PMA Line “Network” Loopback

IEEE 802.3ba Task Force
Dallas, November 10-13, 2008

- This presentation is in support of Comment #643, and proposes that 802.3ba make a PMA Line 'network' loopback mandatory.

10GE PHY Loopbacks

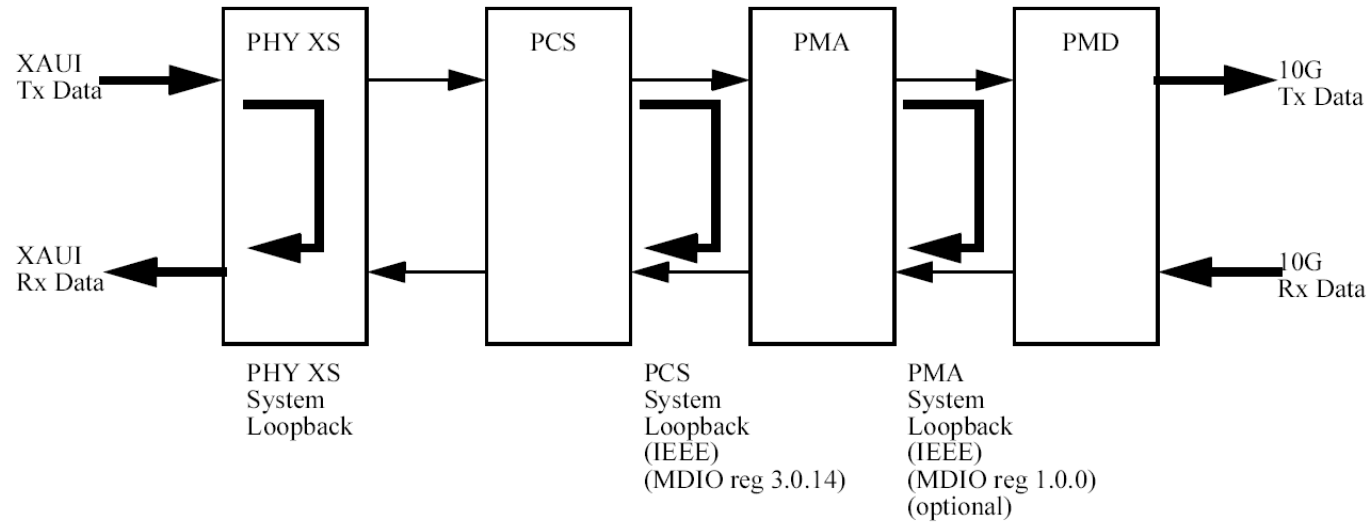
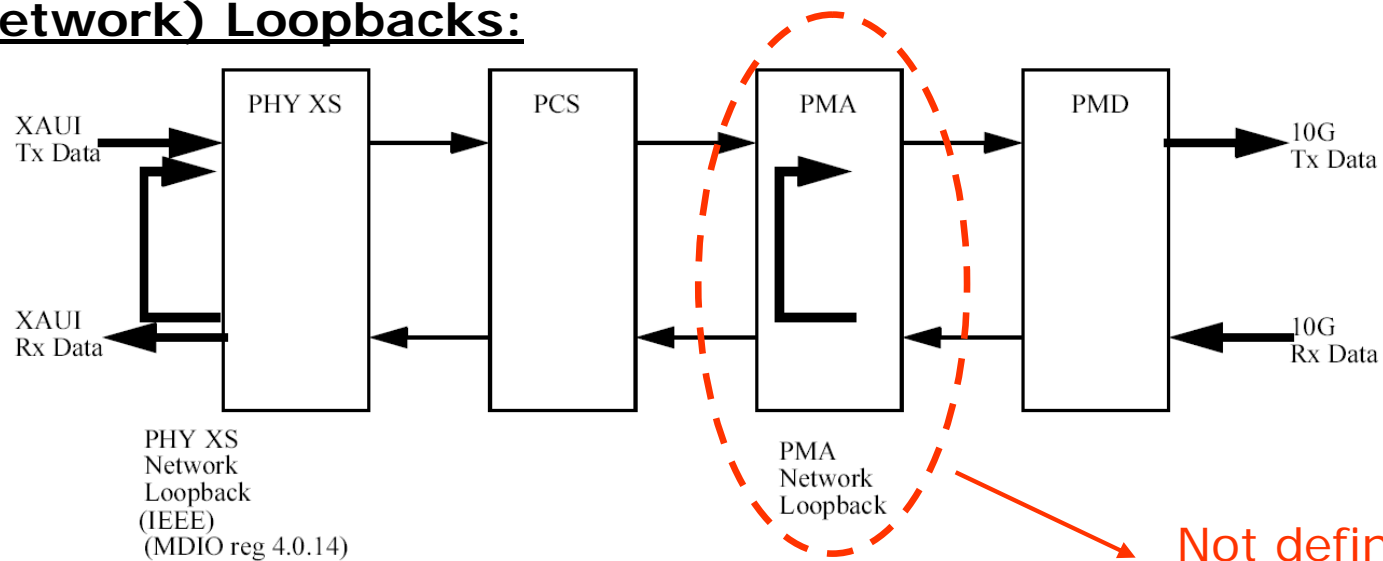
Not defined in 802.3ae for 10GE

- A PMA Line (Network) loopback was not defined in 802.3ae.
- However every PHY device that I am aware of supports a PMA Line Loopback, but at vendor specific MDIO addresses.
- PMA Line Loopbacks are routinely used to isolate facility (fiber) failures from equipment failures, and also to isolate the PMD optics from the rest of a host card for optical parametric testing, i.e. stressed receiver sensitivity, etc (see later)
- Having a widely used function such as 'PMA Line Loopback' implemented with vendor specific MDIO addresses is not ideal (requires vendor specific code on the host)

Example of 10GE PMA Line Loopback

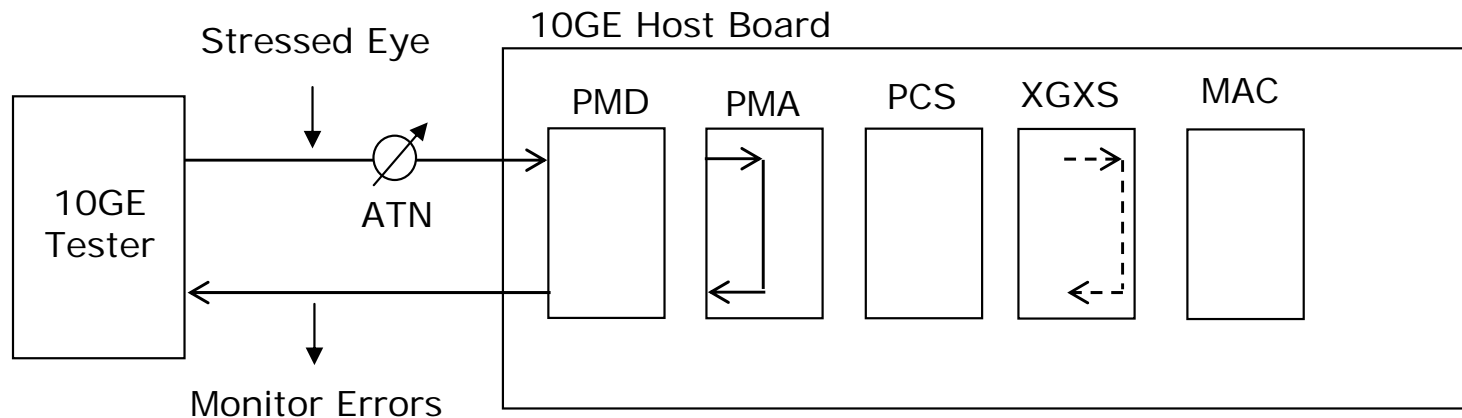
- PMA line loopback control is at a vendor specific MDIO address of 1.C001.4 (and different to other vendors)
- Behavior of PMA line loopback also tends to be vendor specific.

What is PMA Line Loopback used for ?

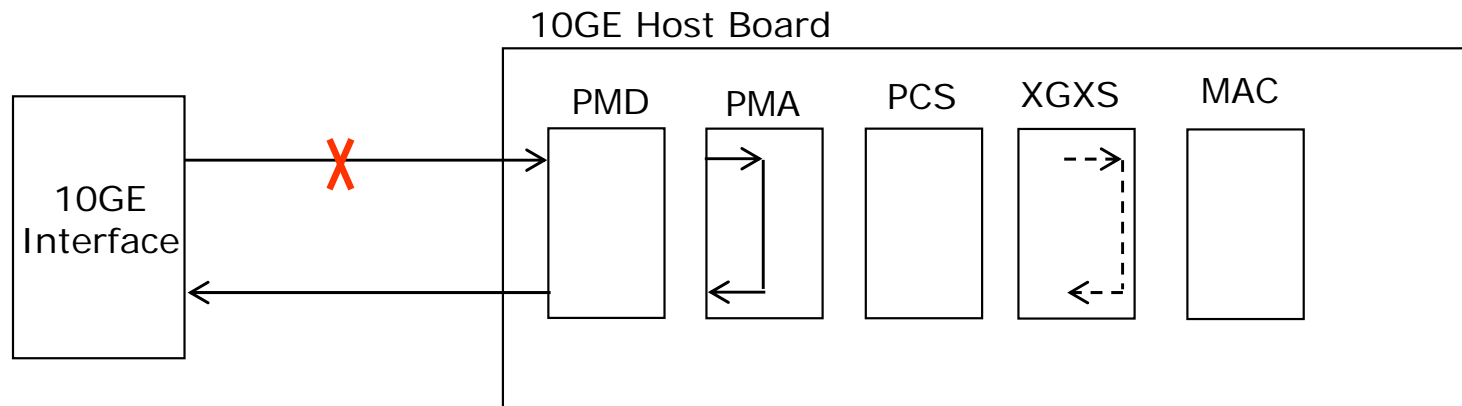
- Having a loopback as close as possible to the ‘faceplate’ of the host card, allows operators to easily isolate whether a failure is due a facility (fiber) issue or an equipment issue
- In the example above putting up a PMA line loopback would quickly point to the fiber as being the cause of the failure. An XGXS loopback would not provide the same confidence.

- As at 10GE expect that all PHY vendors will implement a PMA line loopback, irrespective of whether it is defined in 802.3ba or not
- Recommend that 802.3ba adopt a PMA line loopback, to ensure a consistent implementation across the industry (and avoid what happened at 10GE)
- A PMA line loopback for a generic M:N PMD would be defined as a Rx to Tx loopback on each of the N individual high speed lanes.
